TSB130127
-----------

## Technical Service Bulletin

B Gas Plus CM556, B Gas International CM556, C Gas Plus CM556: Unstable Idle, Idle Surge, Stalls

05d01168

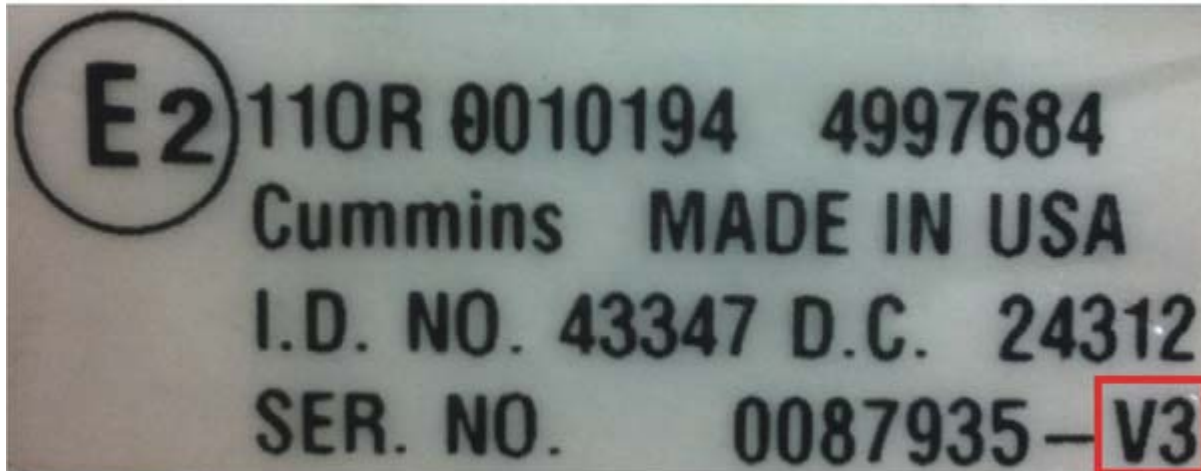
Any B Gas Plus CM556, B Gas International CM556, or C Gas Plus CM556 engine with a V3 FCV, Part Number 4997684, is affected. V3 Fuel Control Valves may be identified by the “-V3” designation next to the serial number, as shown below.

When replacing obsoleted FCV, Part Number 3933841, with the present FCV, Part Number 4997684, the engine calibration **must** be updated at the same time. Reference the table below to determine which calibration is appropriate, based on the ECM Code presently in the engine.
